G15/D18

AL MORAN

MORAN'S WAREHOUSE
DRAINAGE & GRADING PLAN

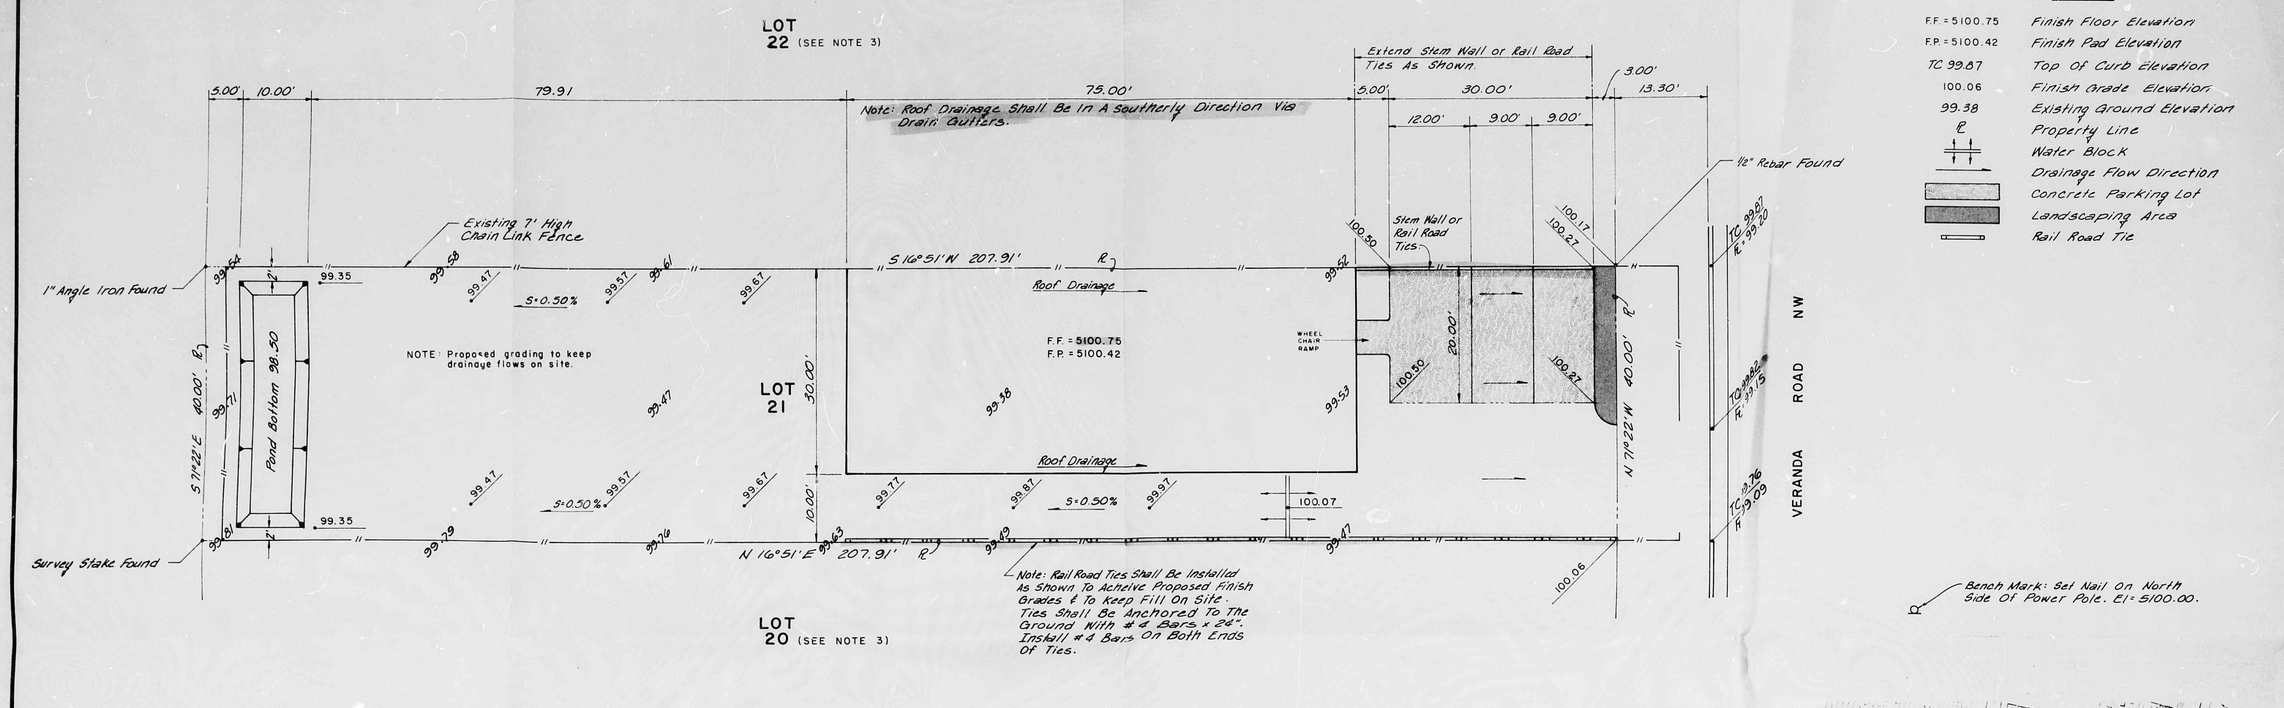
REVISIONS	SCALE:
1. Added more spot elevations both existing & Proposed	1" = 10'
	DATE: 2-1-84
2. Added R.R. Ties & stem wall.	PROJECT NO. 252
3. Added Note 3.	DRAWN: R.M.
	CHECKED: R.B.
	SHEET NO. 1 of 1
